Addendum No. 3

Subject: **Office Facility Alterations and a New Maintenance Building for the:
Fairfield County Board of Developmental Disabilities
795 College Ave
Lancaster, Ohio 43130**

ELECTRICAL
FIRST FLOOR
DEMO WORK
PLAN
 DRAWING NUMBER
E101D

ELECTRICAL
FIRST FLOOR
NEW WORK PLAN
DRAWING NUMBER
E101N

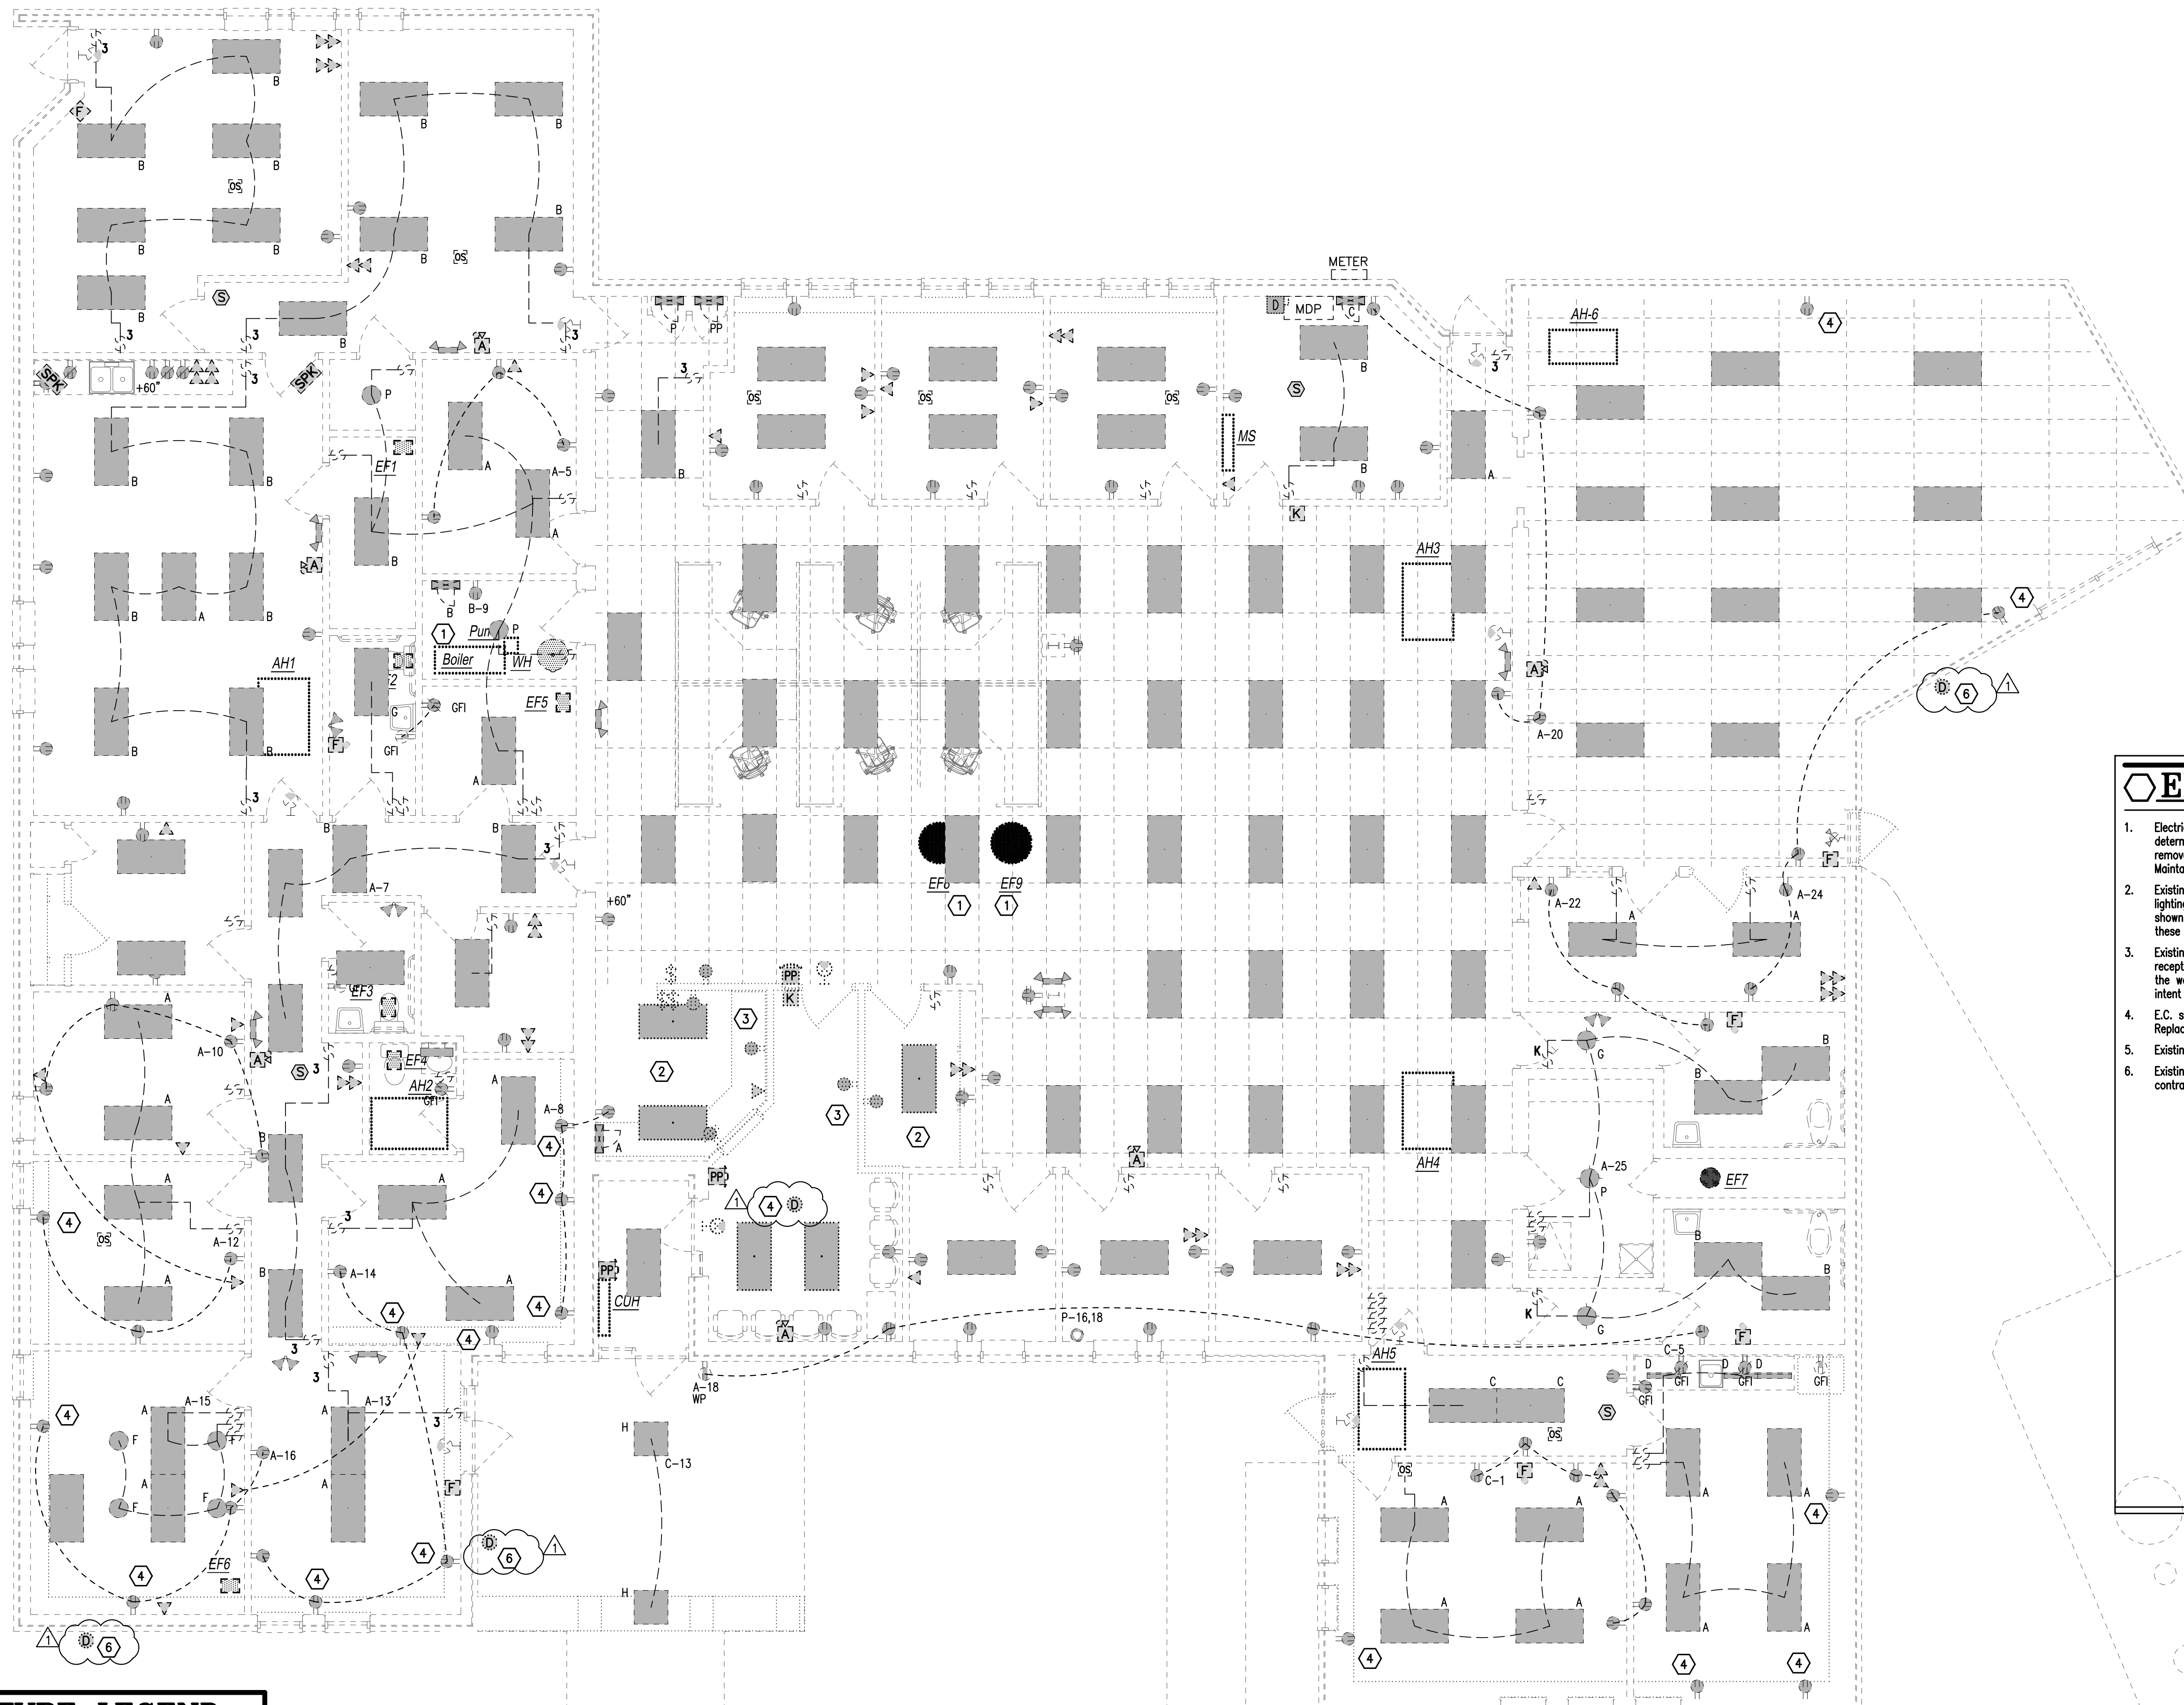
5. The electrical legend does not say which devices PP and K are near the receptionist demo area. Those two devices are drawn to be demolished.

PP is a accessible/ada push paddle for the door operator. K is a swipe for security access. Please see revised E101D and E101N attached for further clarification.

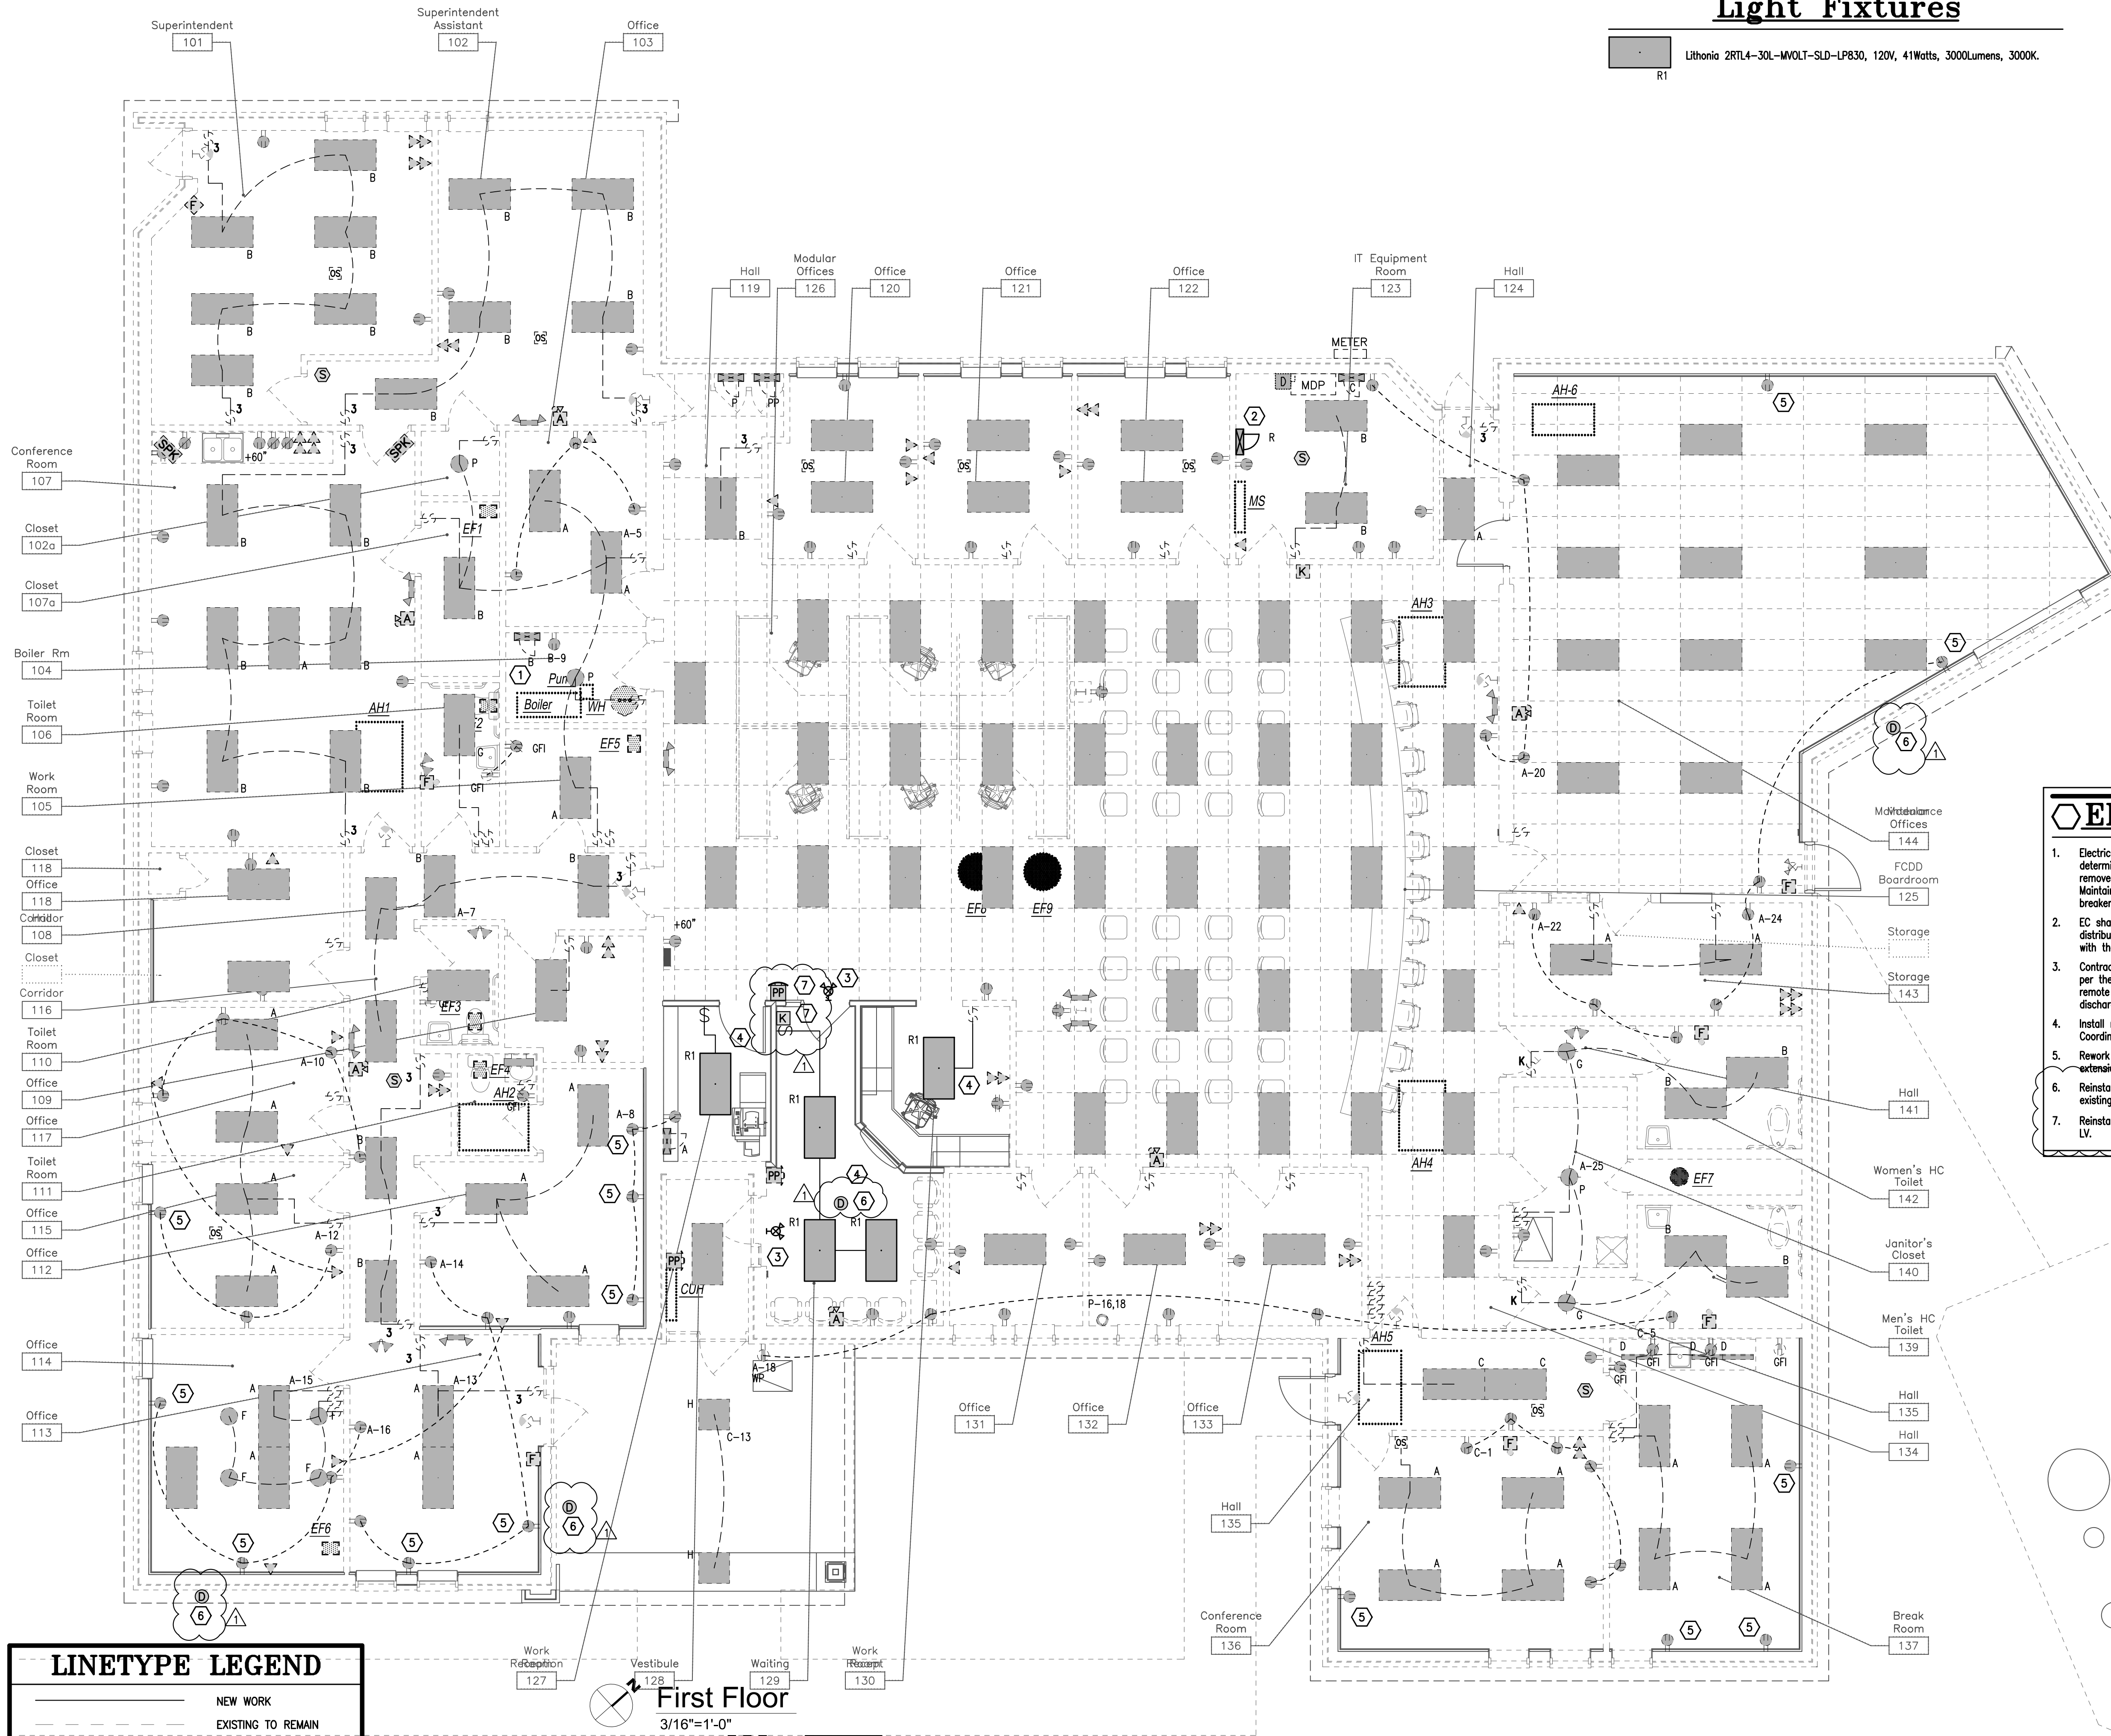
3. Which brand of gear (MSB or MDP) will be feeding the new Panel R?
The existing building has a General Electric fusible switchboard (MSB/MDP).
4. Electrical drawing E101D is conflicting with the architectural showing the demolition of the cameras. Electrical drawing notes say the cameras are to remain. Please confirm.
The best illustration is on A401, coded notes 23 & 24 also coded note 22 as it refers to the exterior illumination. Also see A301, Typical wall section #1, coded note 34 & 35. See also A101.1, coded note 22, A101 coded note 17 & A100.3, coded note 21 as well as A100.2 coded note 15 & A100.1 coded note 14.

A100, Coded Note 23 states "...refer to demolition plan of the electrical", sheet E101D shows coded note #5 "Existing camera to remain" for camera at the main entry, (Note the cameras will be relabeled with coded note #6 for clarity) . Please see revised E101D and E101N attached for further clarification.
